Application for Works Approval Amendment

Works Approval Number	W6265/2019/1
Works Approval Holder	Atlantic Vanadium Pty Ltd
ACN	610 583 090
File Number	DER2019/000145
Premises	Windimurra Vanadium Project Mining tenements: M58/178, M58/279 and M58/280 MOUNT MAGNET WA 6638 As defined by the Premises maps attached to the Revised Works Approval
Date of Report	10 March 2023
Decision	Revised works approval granted

1. Decision summary

Figure 1: Existing and proposed temporary WWTP and irrigation sprayfield layout

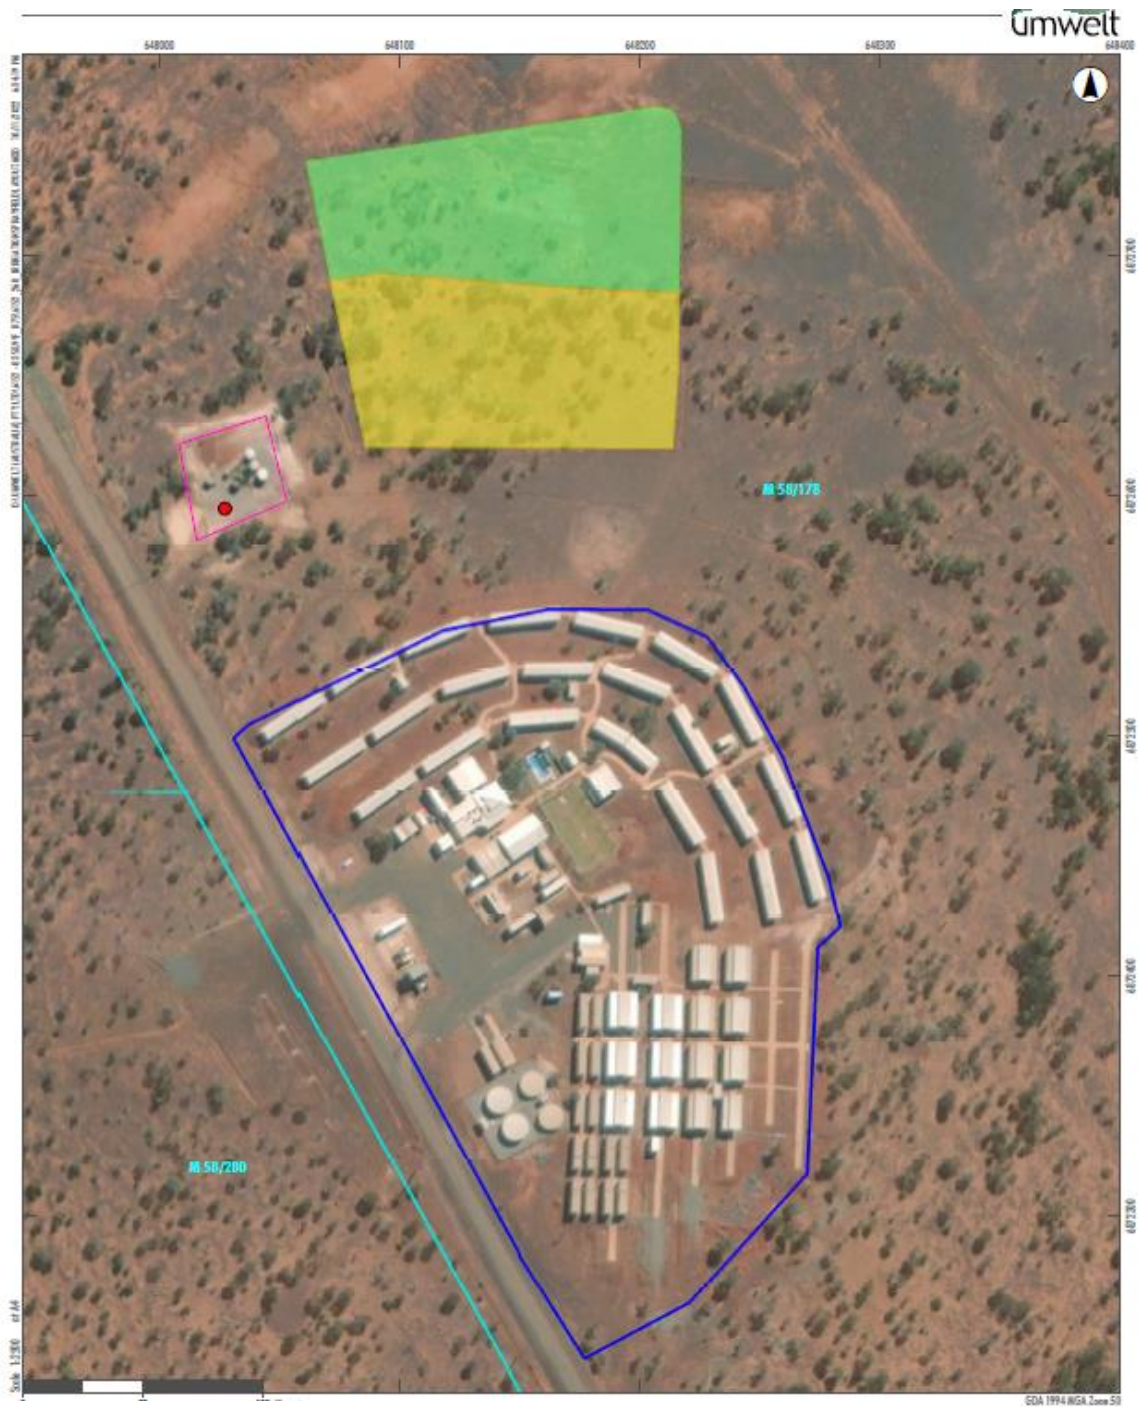
Under this amendment the Works Approval Holder proposes changing the temporary WWTP to a 45 m³/day unit.

The temporary WWTP will run in parallel with the existing WWTP, with sewage distributed to each system through a balance tank. Each WWTP will run an independent disposal system for treated wastewater, which will be irrigated into two separate sprayfield areas as shown in Figure 1.

The existing Works Approval W6265/2019/1 did not authorise TLO for the temporary WWTP. Under this amendment, the Works Approval Holder has requested that TLO for the temporary WWTP be authorised. Refer to section 3 for the department's risk assessment for TLO of the temporary WWTP.
